Response to the Reviewers' Comments

The authors would like to thank the reviewers for the precious comments and suggestions on the technical contents and presentation of our manuscript “Runtime Power Management of Battery Electric Vehicles for Extended Range with Consideration of Driving Time,” submitted to IEEE Transactions on Very Large Scale Integration (TVLSI.) This revised manuscript has been greatly improved thanks to the reviewers’ invaluable advices. We have revised the manuscript faithfully following the reviewers’s comments. We include the newly added or significantly modified parts in the revised version of the paper also in Response to Reviewers. We highlight the important technical content changes and set those parts in a red color in the revised paper.

Fig. 2: (a) Range-speed experimental data for Chevrolet Bolt [36] and (b) comparison with simulation results of the proposed EV power model.

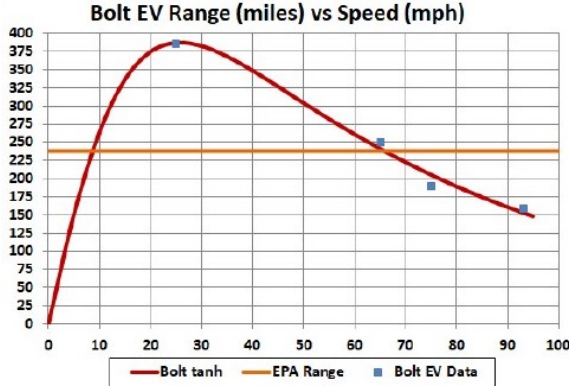
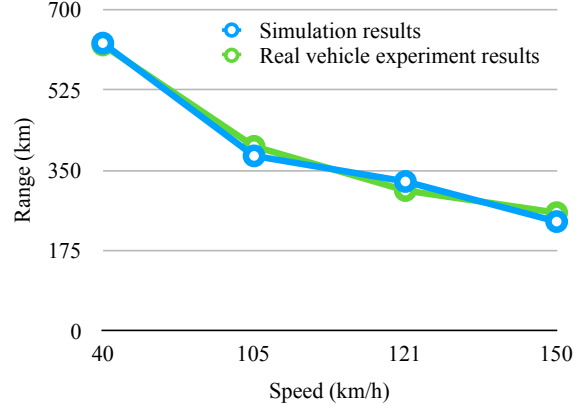
R1-C2 It is not clear how to validate the power model of EV. As the author mentions that accuracy of power model is quite important, it is good to see the power model in this paper can be validated by some real measurement results.

Here goes how we extracted correct coefficients of the EV power equation. We use ADVISOR to extract the model coefficients of new vehicles starting from known vehicle specifications such as the aerodynamic resistance, rolling resistance, curb weight, and so on. Such data is often published in the users' manual, website and so forth. We further use the vehicle performance data such as the top speed, maximum acceleration, and so on, which are also available on the manuals, commercials and websites. We iteratively run ADVISOR and derive the model coefficients so that all the known data values match among each other. The model coefficient extraction result shows as in Fig. 1. The normalized root-mean-square (RMS) deviation is 5.1%. Table I summarizes the model coefficients of (5) for Chevrolet Bolt.

We further evaluate the model accuracy with the range-speed real vehicle experiments as shown in Fig. 2(a) to confirm the derived power models are close enough to the real vehicle measurement data [32], [33], [34], [35], [36]. We refine the coefficients until all the available data values match well.

As a result, the derived EV power model well matches with the range-speed experimental data as shown in Fig. 2(b) as well as the top speed and maximum acceleration setting the aerodynamic resistance, rolling resistance, curb weight, etc. with the known values. The errors in the range-speed simulation is merely 1.4%, the time for 0-to-100 km/h error is 7.8%, and the top speed error is 3.0%, respectively. We revised the manuscript adding the following paragraph with a new figure in Section III.A on page 3 and 4.

As a result, the derived EV power model well matches with the range-speed experimental data as shown in Fig. 2(b) as well as the top speed and maximum acceleration setting the aerodynamic resistance, rolling resistance, curb weight, etc. with the known values. The errors in the range-speed simulation is merely 1.4%, the time for 0-to-100 km/h error is 7.8%, and the top speed error is 3.0%, respectively.

Fig. 12: Velocity profile comparison with EDP , E^2DP and E^3DP on Serrano Avenue in Anaheim Hills.

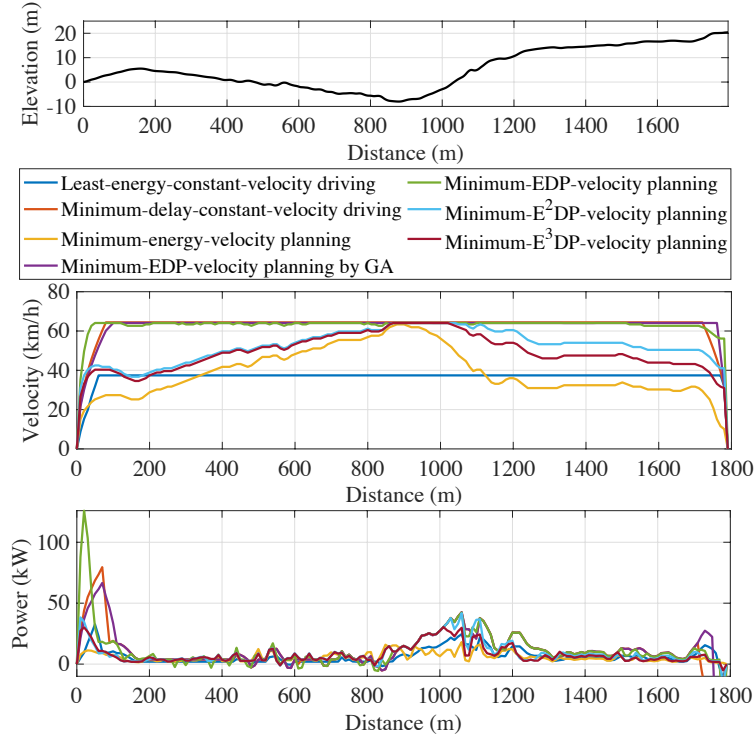
R1-C3 The optimality of the proposed scheduling algorithm is unclear. The author should add several paragraphs to discuss this topic. It is also to see the comparison baseline is well accepted to show the advantage of the proposed algorithm.

We also updated Fig. 12 and Fig. 13:

Fig. 11: Histograms of velocity and acceleration for the proposed energy-aware-velocity planning methods without an acceleration constraint (a) and (b) and with an acceleration constraint (c) and (d), respectively.

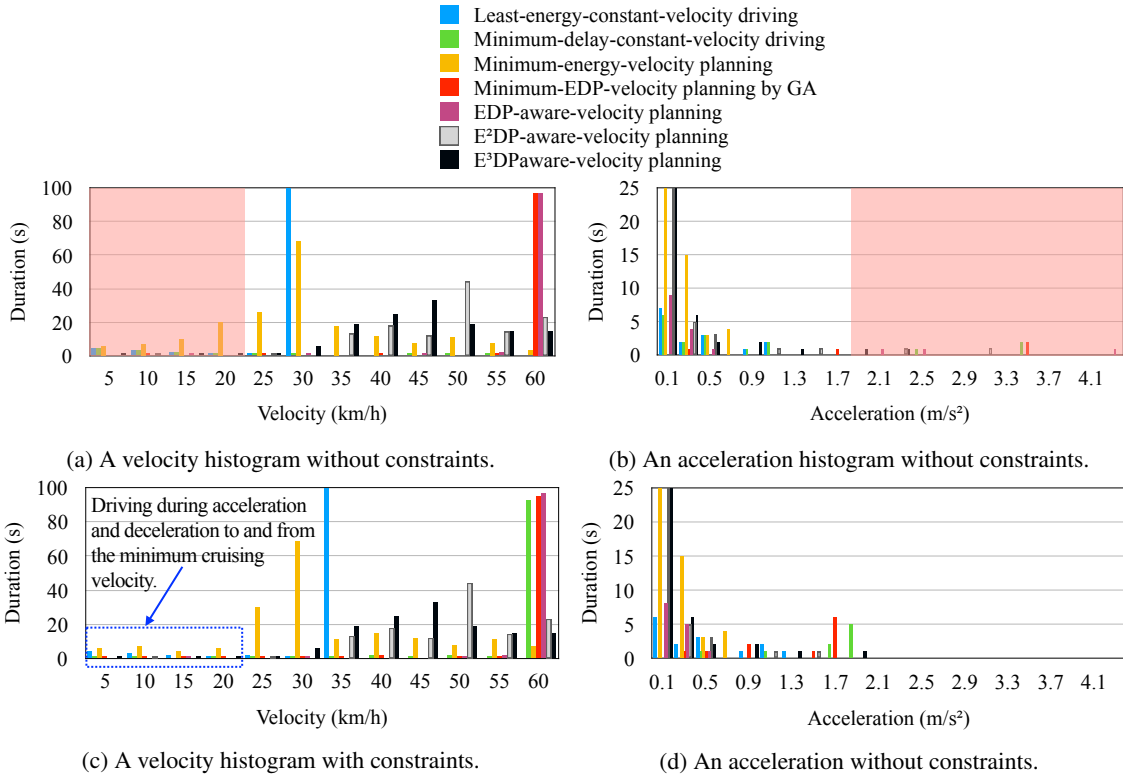
R2-C2 It would be good to have more discussion on the assumptions of the approach and the experiments, e.g., how much can the velocity be changed in practical scenarios without impeding traffic and causing unsafe situations (also depending on the road conditions and whether it is urban or rural environment I suppose). Currently, there only seems to be one constraint on not slower than 10 km/h.

We quantize the velocity and acceleration values and make a histogram to analyze population of velocity and acceleration for the proposed energy-aware-velocity planning methods. Fig. 11(a) and (b) show two histograms of the driving schemes in Fig. 12, which do not have velocity and acceleration constraints. We avoid a cruising velocity lower than 25 km/h and an acceleration higher than 2.0 m/s^2 in this paper without loss of generality. The acceleration of 2.0 m/s^2 is the same as the maximum acceleration of compact cars designed to be used primarily used in urban areas (13 seconds of 0-to-100 km/h time).

Fig. 11(c) and (d) shows the velocity and acceleration histograms with the constraints. Once we run the DP for the first time without constraints, we analyze the histogram, adaptively determine the minimum cruising velocity and maximum acceleration constraints, and run DP again. We keep the same constraints for online recomputation whenever unexpected interrupts occurs.

We quantize the velocity and acceleration values and make a histogram to analyze population of velocity and acceleration for the proposed energy-aware-velocity planning methods. Fig. 11(a) and (b) show two histograms of the driving schemes in Fig. 12, which do not have velocity and acceleration constraints. We avoid a cruising

velocity lower than 25 km/h and an acceleration higher than 2.0 m/s^2 in this paper without loss of generality. The acceleration of 2.0 m/s^2 is the same as the maximum acceleration of compact cars designed to be used primarily used in urban areas (13 seconds of 0-to-100 km/h time).

Fig. 11(c) and (d) shows the velocity and acceleration histograms with the constraints. Once we run the DP for the first time without constraints, we analyze the histogram, adaptively determine the minimum cruising velocity and maximum acceleration constraints, and run DP again. We keep the same constraints for online recomputation whenever unexpected interrupts occurs.

Fig. 8: Altitude changes in the real road benchmarks.

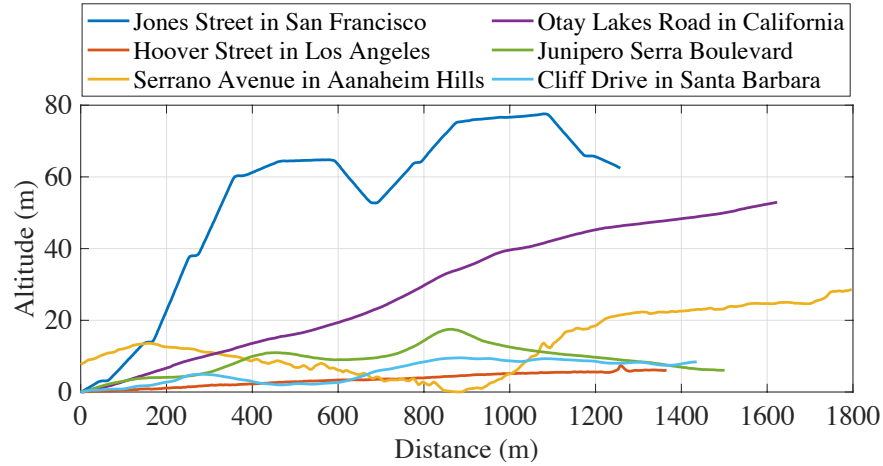
R2-C3 Related to the last point, it would be good to have more discussion on the road benchmarks, e.g., how they are generated and how representative they are. The optimization results significantly depend on road slope. It would be good to use a variety of real road segments for testing.

R2-A3 We appreciate the reviewer's comment. We replaced the previous synthetic road benchmarks with the real road benchmarks. We made six new real road benchmarks from various locations in California. The first three roads are in cities. Jones Street in San Francisco and Hoover Street in Los Angeles are two representative city landscapes such as hills and flat roads, respectively, and Cliff Drive in Santa Barbara is a mixture of those. The second two roads are in mountain areas: Serrano Avenue in Anaheim Hills and Otay Lakes Road in San Ysidro Mountain in California. The last road is Junipero Serra Boulevard connecting San Francisco and San Jose. The details of road data is summarized in Table II, and Fig. 8, which visualize the altitudes of the road benchmarks. We also revised all the associated contents with the new real road benchmarks.

We choose six roads from various locations in California and make real road benchmarks. The first three roads are in cities. Jones Street in San Francisco and Hoover Street in Los Angeles are two representative city landscapes such as hills and flat roads, respectively, and Cliff Drive in Santa Barbara is a mixture of those. The second two roads are in mountain areas: Serrano Avenue in Anaheim Hills and Otay Lakes Road in San Ysidro Mountain in California. The last road is Junipero Serra Boulevard connecting San Francisco and San Jose. The details of road data is summarized in Table II, and Fig. 8, which visualize the altitudes of the road benchmarks.
